**802.1 maintenance item 0319:  
Race condition in 802.1Q-2018  
between List Config state machine  
(clause 8.6.9.3) and Cycle Timer  
state machine (clause 8.6.9.1)**

*Alon Regev*

**AUG 11, 2021**

# Potential Solution #1 – part 1

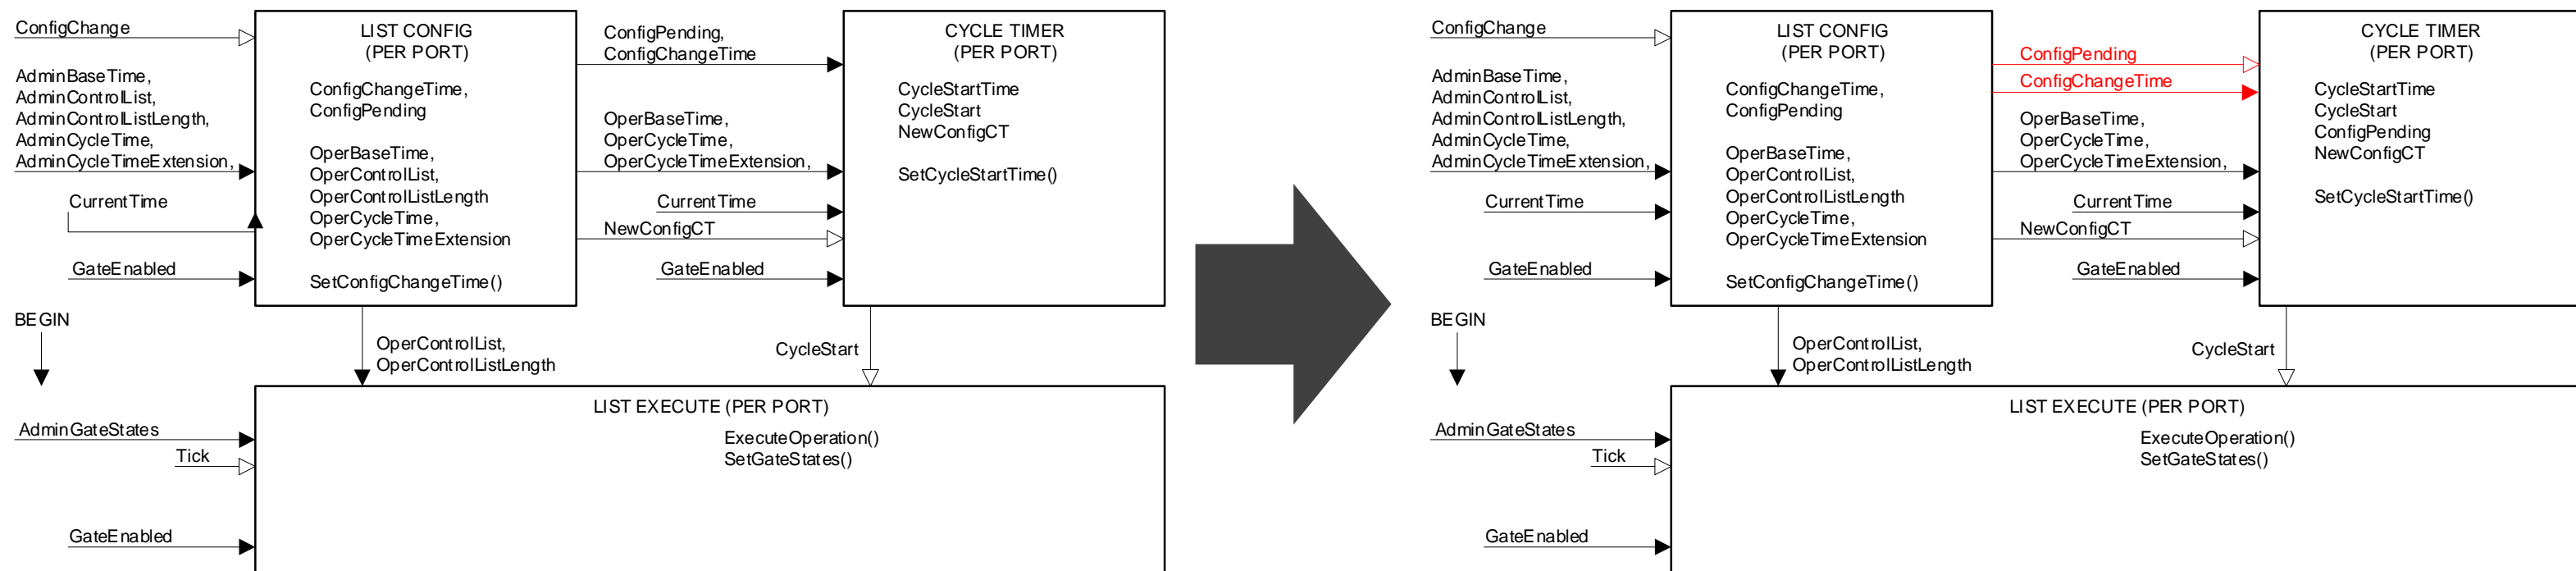
- In Clause 8.6.9.3 , Figure 8-18 (Scheduled traffic state machines—overview and relationships):
  - On the arrow with the text “ConfigPending, ConfigChangeTime”, change the text to “ConfigPending” and change the arrow shape to be one with the outline only (no fill).
  - Add an arrow underneath the ConfigPendingArrow starting at the “LIST CONFIG” box and ending at the “CYCLE TIMER” box with the text “ConfigChangeTime”, no arrow at the LIST CONFIG SIDE, and a filled in arrow at the CYCLE TIMER side.

# Proposed solution #1 – part 2

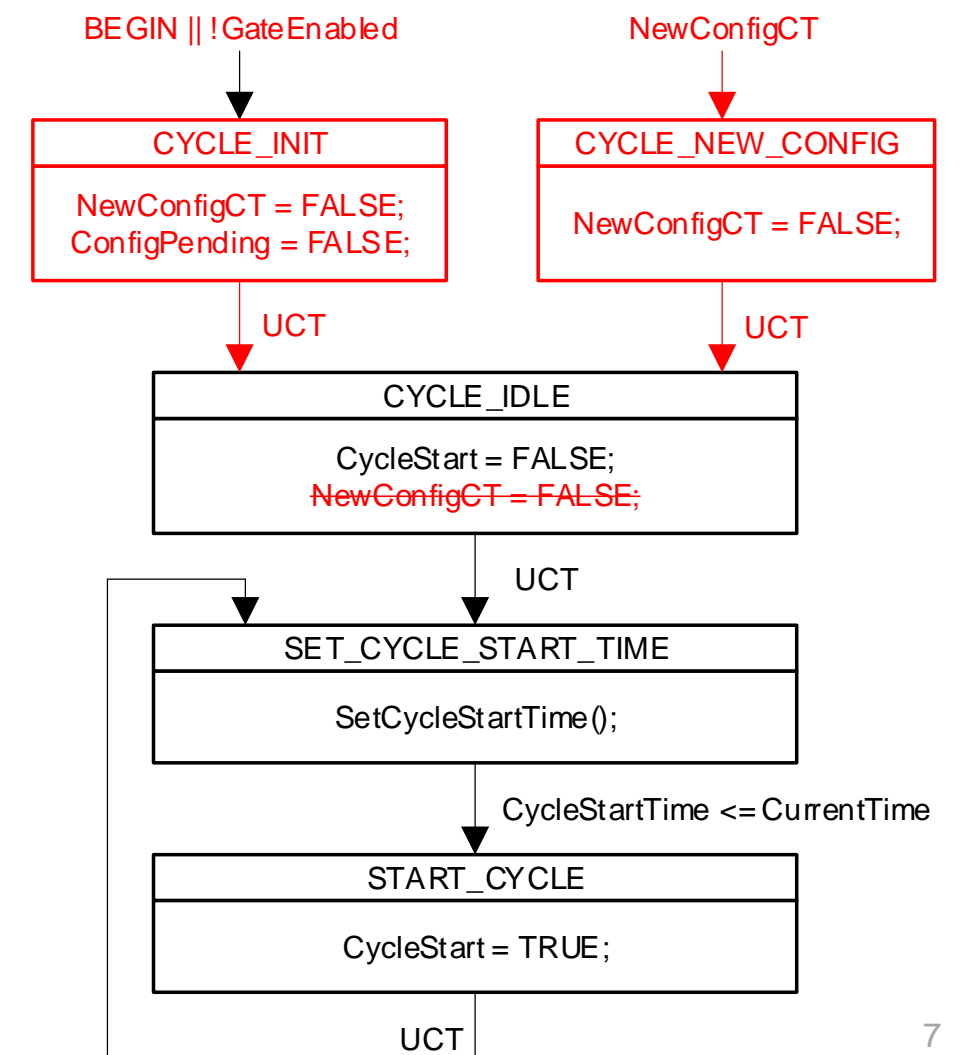
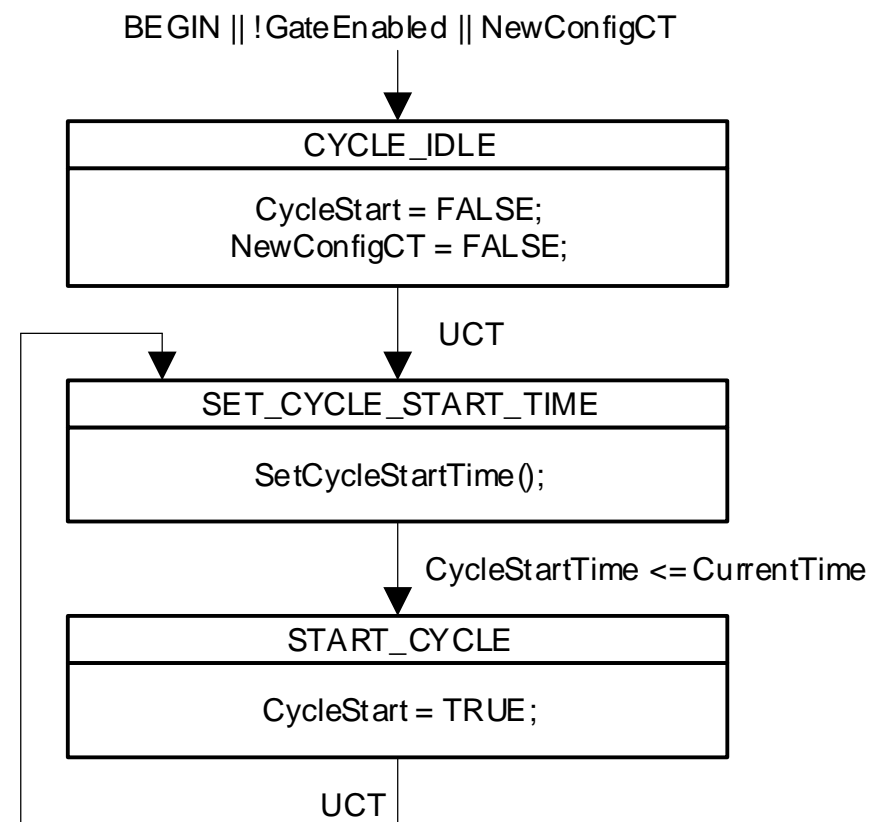
- In Clause 8.6.9.1 , Figure 8-19 (Cycle Timer State Machine):
  - Remove the global transition from “BEGIN || !GateEnabled || NewConfigCT” to CYCLE\_IDLE

- Add a new state named “CYCLE\_INIT”
    - This state will contain the lines “NewConfigCT = FALSE;” and “ConfigPending = FALSE;”
  - Add a global transition from “BEGIN || !GateEnabled” to the new CYCLE\_INIT state

- Add a new state named “CYCLE\_NEW\_CONFIG”
    - This state will contain the line “NewConfigCT = FALSE;”
  - Add a global transition from “NewConfigCT” to the new CYCLE\_INIT state

- Add an UCT transition from the CYCLE\_INIT state to the CYCLE\_IDLE state
  - Add an UCT transition from the CYCLE\_NEW\_CONFIG state to the CYCLE\_IDLE state

- Add an UCT transition from the CYCLE\_IDLE state to the SET\_CYCLE\_START\_TIME state
  - Add an UCT transition from the SET\_CYCLE\_START\_TIME state to the START\_CYCLE state

- Add an UCT transition from the START\_CYCLE state to the SET\_CYCLE\_START\_TIME state
  - Remove the line “NewConfigCT = FALSE;” from the CYCLE\_IDLE state

# Potential Solution #1 – part 3

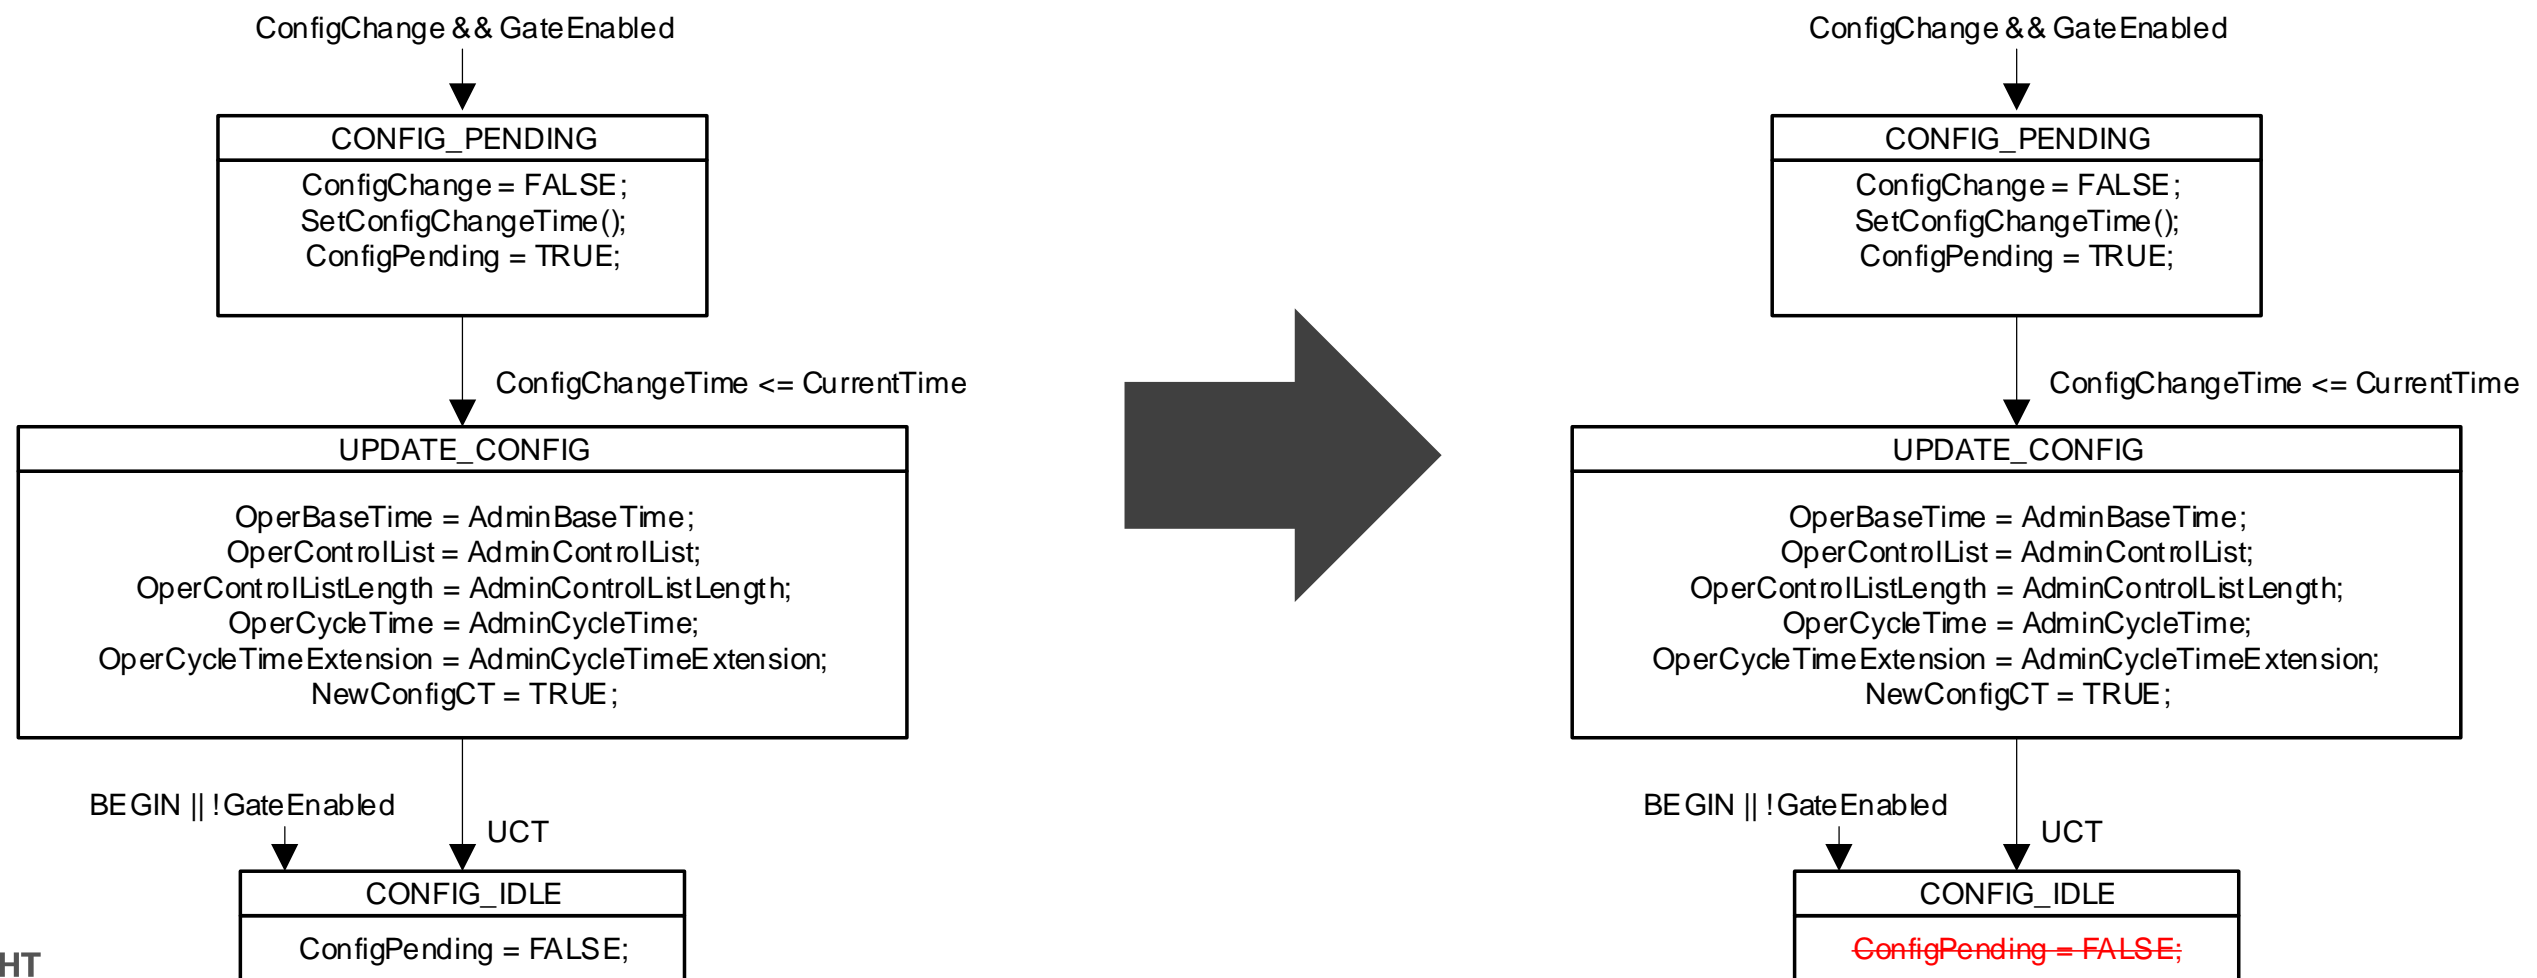
- In Clause 8.6.9.1.1 (SetCycleStartTime() ), section “d)”
  - Following “CycleStartTime = ConfigChangeTime”, add a line containing “set ConfigPending = FALSE”

d) If:  
ConfigPending = TRUE, and  
ConfigChangeTime  $\leq$  (CurrentTime + OperCycleTime + OperCycleTimeExtension)  
Then:  
CycleStartTime = ConfigChangeTime  
set ConfigPending = FALSE

# Potential Solution #1 – part 4 revised

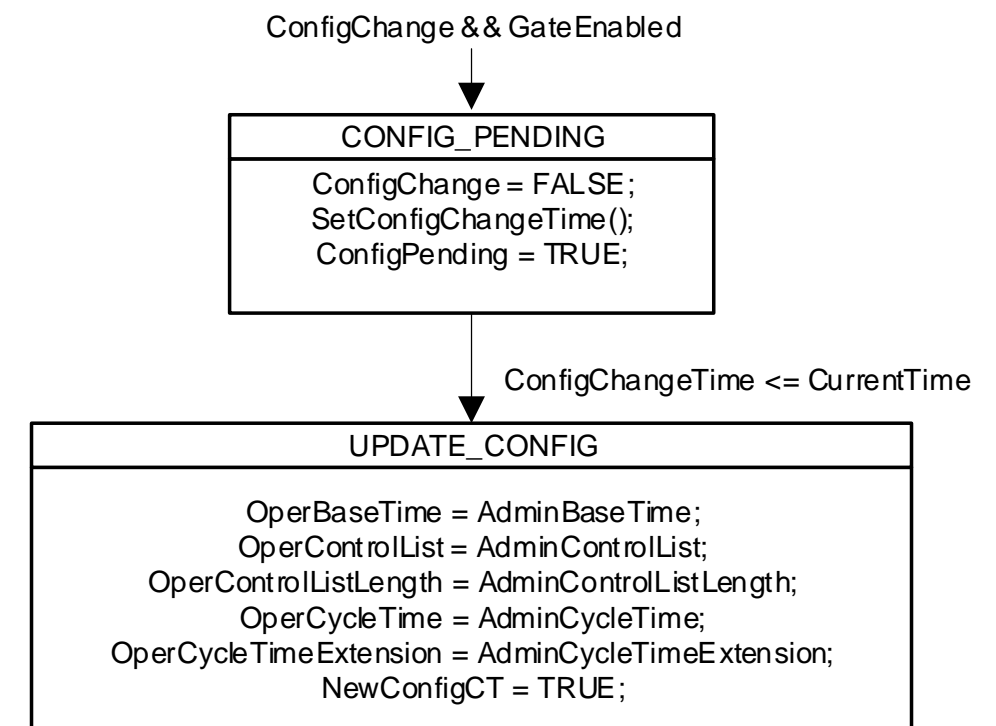
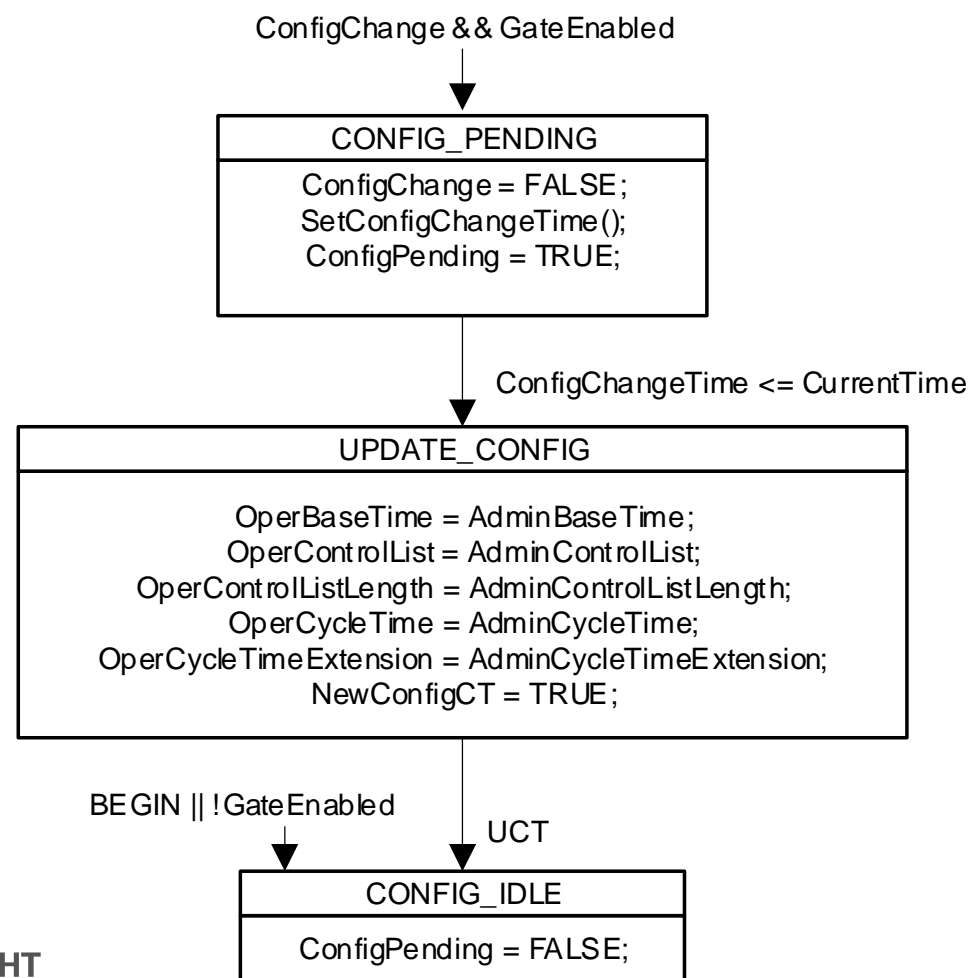
- In Clause 8.6.9.3 , Figure 8-21 (List Config State Machine):
  - In the CONFIG\_IDLE block, remove the “ConfigPending = FALSE;” line

In the 802.1 maintenance meeting On Aug 11, 2021 this was discussed and recommendation was to get rid of the CONFIG\_IDLE state as it is empty. This will be shown in the next slide

- In Clause 8.6.9.3 , Figure 8-21 (List Config State Machine):
  - Remove the CONFIG\_IDLE state and all transitions to it.

This is the new proposal as per the discussion in the 802.1 maintenance meeting on August 11, 2021

# Proposed solution #2 – part 1

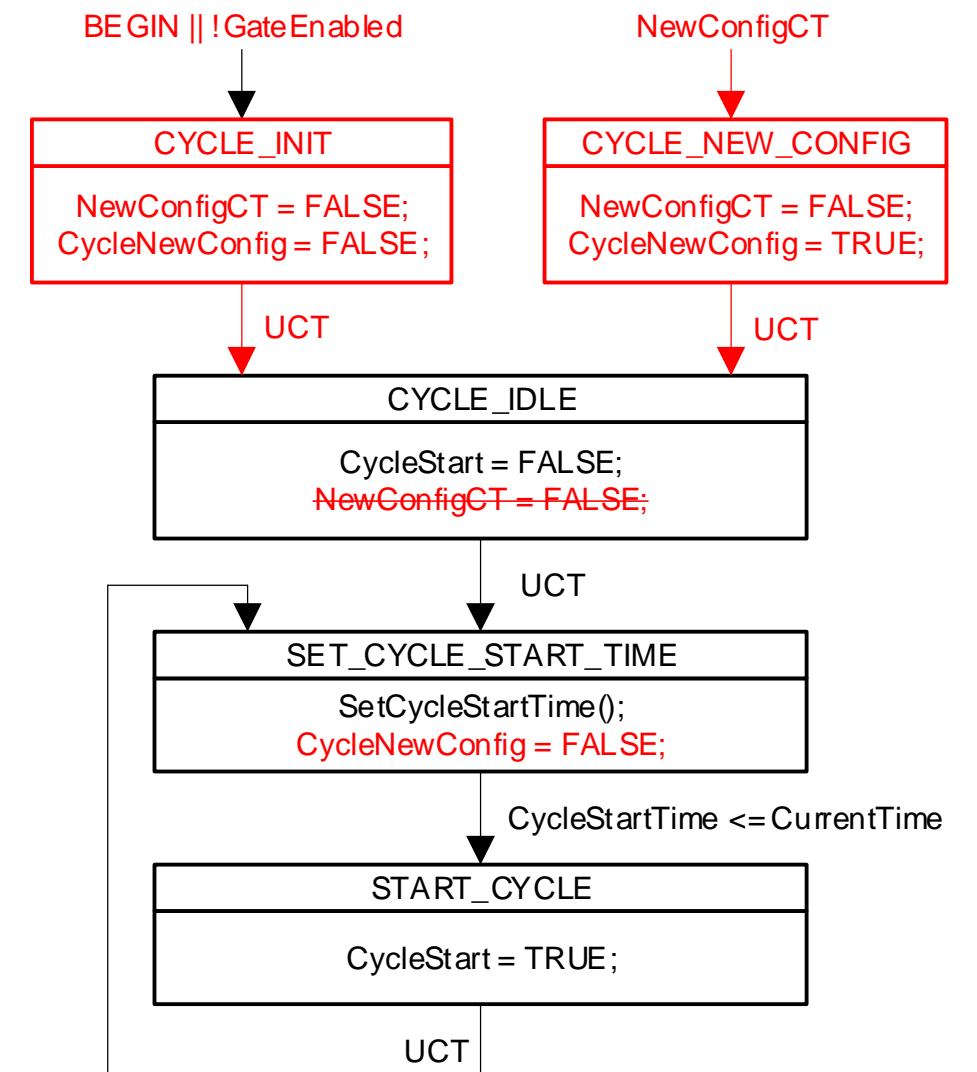
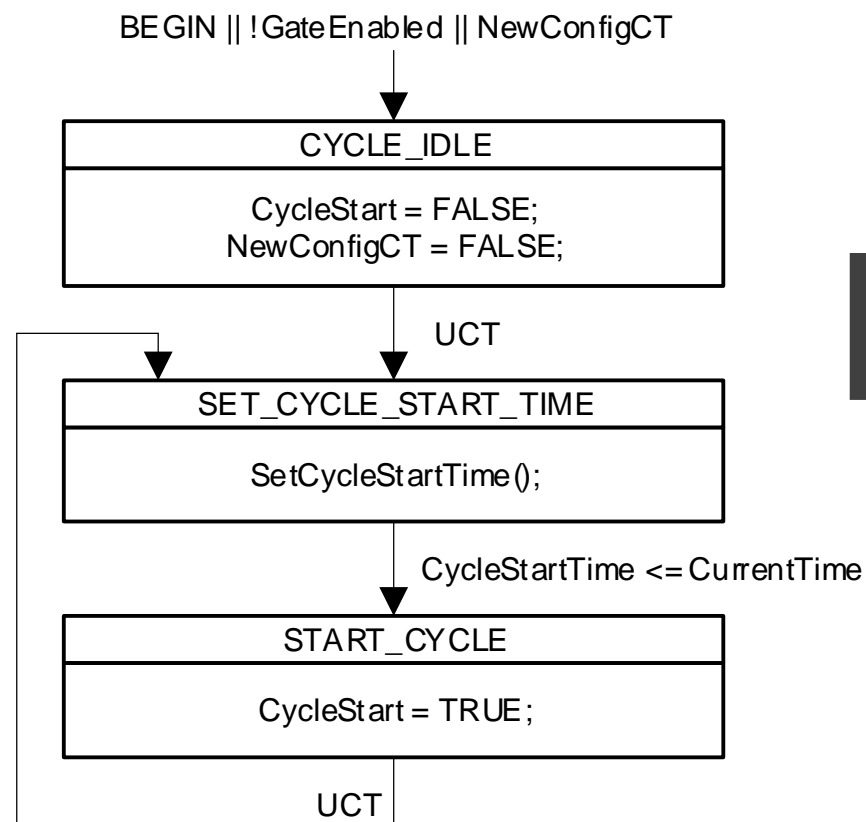
- In Clause 8.6.9.1 , Figure 8-19 (Cycle Timer State Machine):
  - Remove the global transition from “BEGIN || !GateEnabled || NewConfigCT” to CYCLE\_IDLE

- Add a new state named “CYCLE\_INIT”
    - This state will contain the “NewConfigCT = FALSE;” and “CycleNewConfig = FALSE;”
  - Add a global transition from “BEGIN || !GateEnabled” to the new CYCLE\_INIT state

- Add a new state named “CYCLE\_NEW\_CONFIG”
    - This state will contain the “NewConfigCT = FALSE;” and “CycleNewConfig = TRUE;”
  - Add a global transition from “NewConfigCT” to the new CYCLE\_NEW\_CONFIG state

- Add an UCT transition from the CYCLE\_INIT state to the CYCLE\_IDLE state
  - Add an UCT transition from the CYCLE\_NEW\_CONFIG state to the CYCLE\_IDLE state

- Remove the line “NewConfigCT = FALSE;” from the CYCLE\_IDLE state
  - In the SET\_CYCLE\_START\_TIME, after “SetCycleStartTime()” add a new line containing “CycleNewConfig = FALSE;”
